**TECHNICAL MEMORANDUM**

SUBJECT: Conceptual Design for Sonoita Creek, AZ, Technical Review Support (Order  
Number EP-G149-00241)

Figure 2a. Hydrologic soil group map and color-coded ratings for Sonoita Creek area (see next page for map legend).

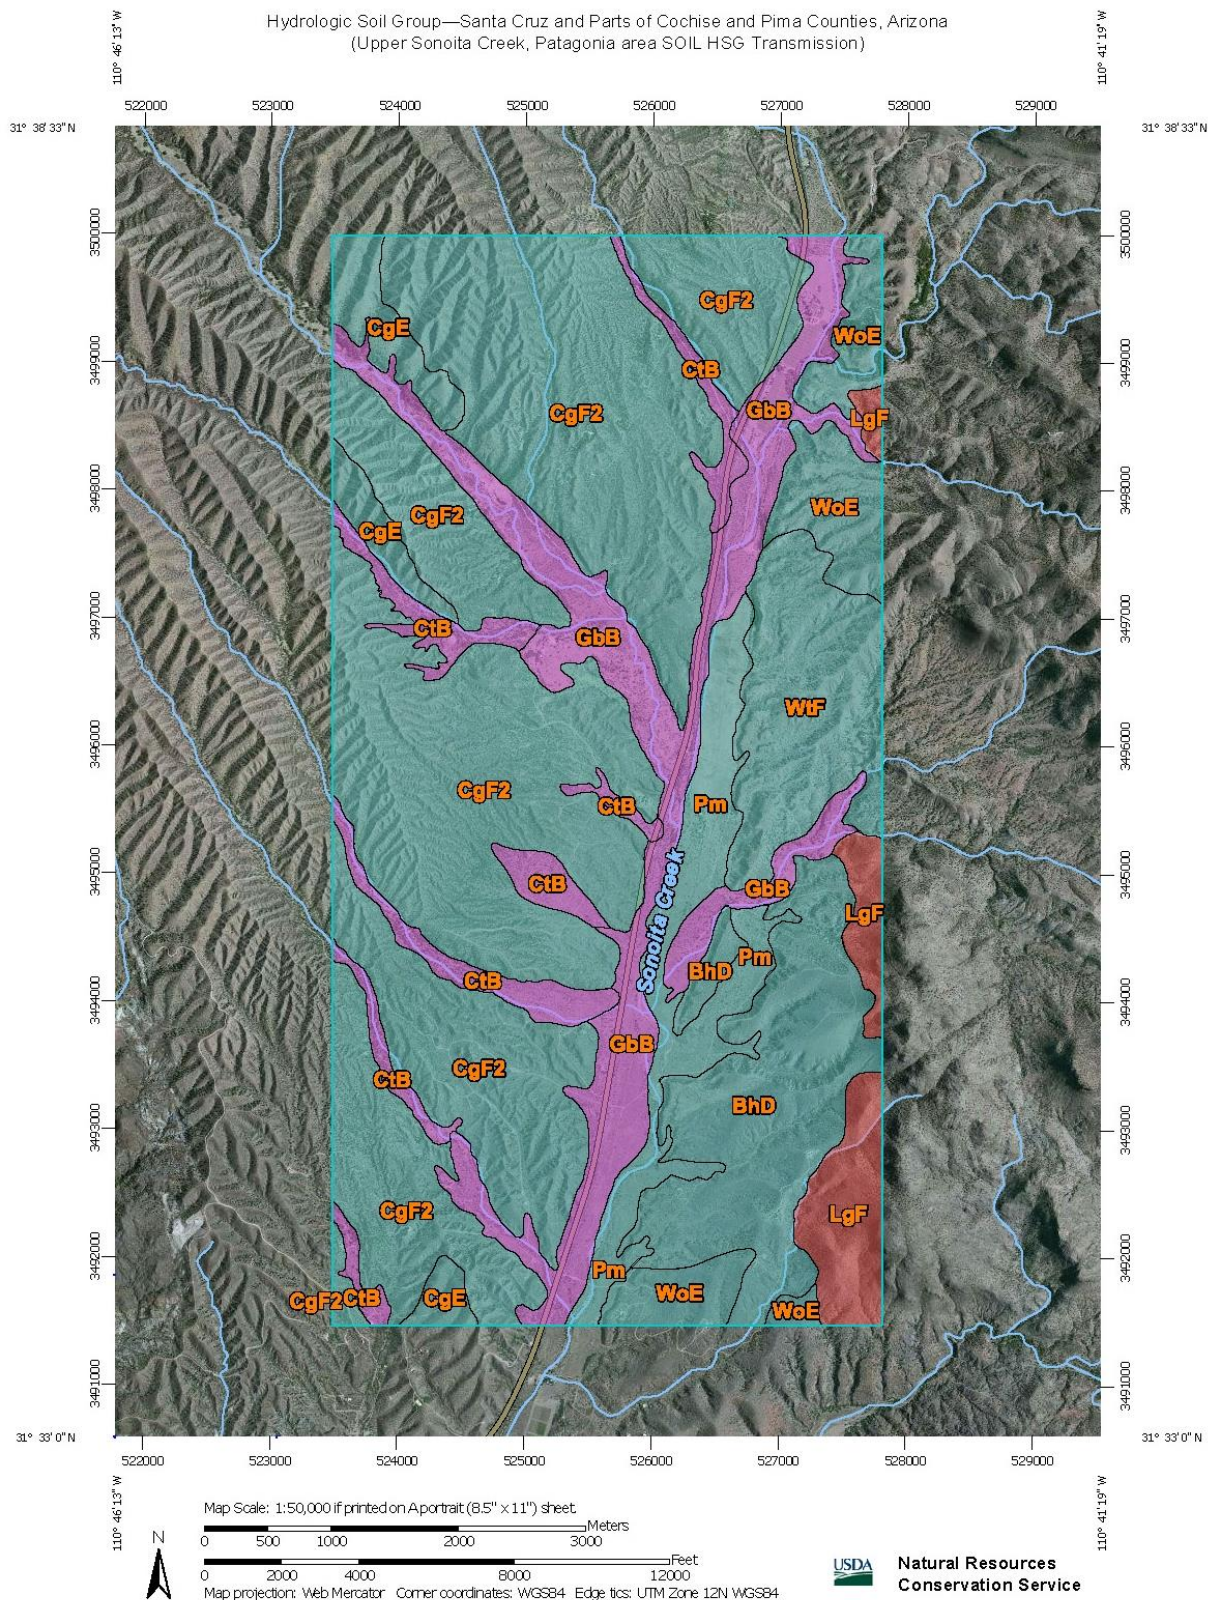
- 3) **The proposed constructed channels will likely not sustain flow in the specific soil types within the project reach.** The Sonoita Creek valley bottom consists primarily of alluvial deposits. In terms of mapped soil units, it is dominated by Grabe-Comoro complex (GbB) soils of gravelly sandy loam to sandy loam composition, that receive a hydrologic soil group classification (HSG) of Group A (refer to Figure 2a and 2b). Group A soils are characterized by high infiltration rates, low runoff potential, and a high rate of water transmission. The Sonoita Creek floodplain also has a lesser percentage of Pima soils (Pm), a clay loam that receives a HSG classification of Group C. Group C soils are characterized by slow infiltration rates and slow water transmission.

Transmission losses due to infiltration into the bed and banks are high in semiarid ephemeral streams, and multiple researchers have demonstrated that except during the highest flows, there is significant loss of in-stream flow due to seepage as the flow proceeds downstream in alluvial valleys (Levick, et al. 2008). The WET report (p.12) notes that transmission losses for streams like Sonoita Creek have been reported as high as 17-29%. Approximately half of the constructed pilot channels as proposed in the plan would be excavated into the highly permeable Grabe-Comoro complex soils, resulting in high transmission losses. Any portion of the flow that entered the newly constructed channels during low to moderate flow rate events, such as those that occur at a high frequency annual scale, would likely not be sustained, and likely not return to the main Sonoita Creek channel. Sediment drops out of suspension as infiltration occurs and flow drops in velocity, depositing new material in the channel. Resulting aggradation may fill the newly constructed channels, further restricting the ability of flows to be diverted and for any diverted flow to successfully return to the main Sonoita Creek channel, particularly at the downstream reaches of constructed channels. Continued aggradation in the constructed channel could eventually create an abandoned, non-functional channel. The overall result would be a loss of habitat in the main channel of Sonoita Creek and a failure to create new habitat in the constructed channels, therefore failing to meet the stated goals of the proposed design in the WET report.
